Access Compliance Report

Public Rights-of-Way

(Curb Ramps)

Intersection ID: 10353	Main Street: E_35TH_ST	Cross Street: N_MCDOWELL_ST	Location: E
ADA ID: 1BECAB99D1EF	Ramp Type: Perp	Initial Pass/Fail: Fail	Overall Compliance: No
Severity Score: 26.25			
Codes/Mitigation Info/Possible Solution		Field Measurements/Component Compliance

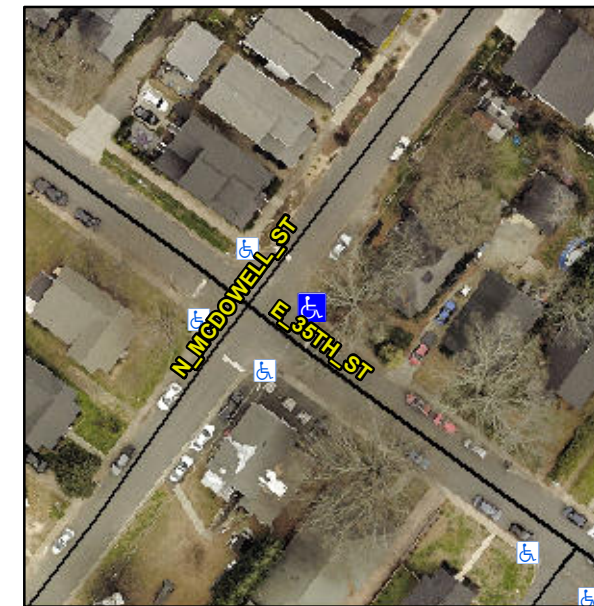
Not Found, R304.2.2, R304.5.3

Compliance	Description	Data	Compliance	Description	Data
N/A	Ramp Length (in)	36.5	No	Ramp Slope (%)	13.8
Yes	Ramp Width (in)	58.0	No	Ramp XSlope (%)	2.3
N/A	Flare Type LT	N/A	N/A	Flare Type RT	N/A
N/A	Flare Slope LT (%)	N/A	N/A	Flare Slope RT (%)	N/A
N/A	Flare Traversable LT?	N/A	N/A	Flare Traversable RT?	N/A
N/A	Landing Length (in)	N/A	N/A	DWS Provided?	N/A
N/A	Landing Width (in)	N/A	N/A	DWS Contrast?	N/A
N/A	Landing Slope (%)	N/A	N/A	DWS Length (in)	N/A
N/A	Landing X Slope (%)	N/A	N/A	DWS Full Width?	N/A
N/A	Landing Curb? (Y/N)	N/A	N/A	DWS Offset (in)	N/A
N/A	Shared Landing?	N/A			
N/A	Gutter Ponding?	N/A	N/A	Gutter Slope (%)	N/A
N/A	Gutter Lip Ht (in)	N/A	N/A	Gutter X Slope (%)	N/A
N/A	Painted X Walk1?	No	N/A	Painted X Walk2?	N/A
	X Walk 1 Direction	To NW		X Walk 2 Direction	N/A
N/A	X Walk 1 Width (in)	N/A	N/A	X Walk 2 Width (in)	N/A
	X Walk 1 Slope (%)	1.5		X Walk 2 Slope (%)	N/A
	X Walk 1 X Slope (%)	0.1		X Walk 2 X Slope (%)	N/A

Remove & Replace Entire Ramp.
